The above proposed Technical Specifications changes are requested in order to satisfy NUREG-0472 and staff guidance in the development of Radiological Effluent Technical Specifications.

Consumers Power Company
Palisades Plant - Docket 50-255

TECHNICAL SPECIFICATION CHANGE REQUEST

**SITE ENVIRONMENT
TLD STATIONS**
**PALISADES NUCLEAR PLANT
SITE BOUNDARY**
FIGURE 5-1

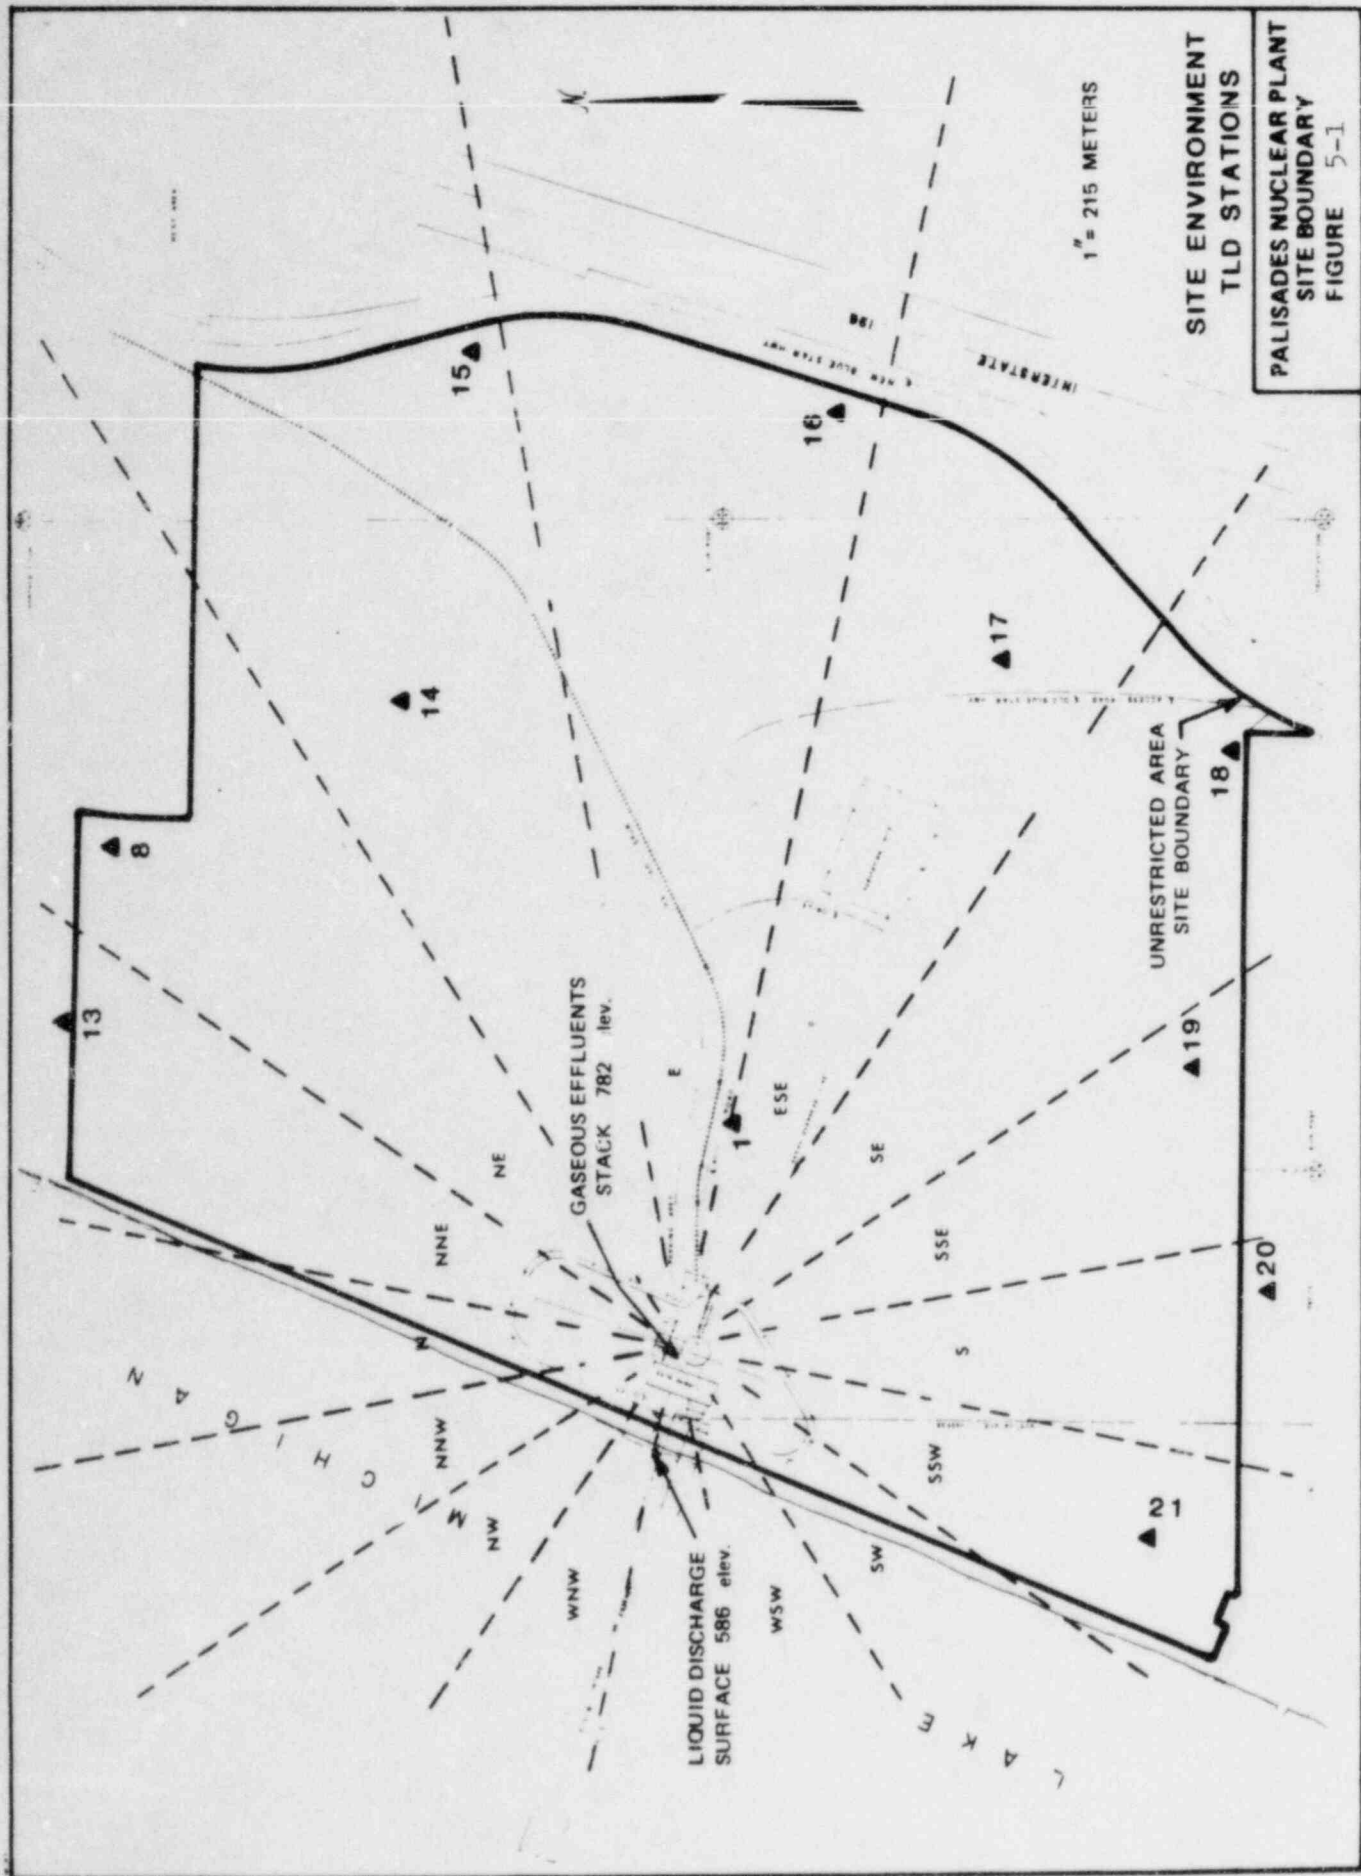
- M. Change the second sentence of Section 5.1 Site to read "Figure 5-1 shows the plan of site."
- N. Add Figure 5-1 "Palisades Nuclear Plant Site Boundary" at the end of Section 5.

- M. and N. A new figure was created for this submittal that clearly shows the site boundary.
- O. and P. Section 6.5.2.8.3 was added and referenced in 6.5.2.8.1.e to delineate NSB responsibilities for ODCM, PCP and radiological environmental monitoring program.
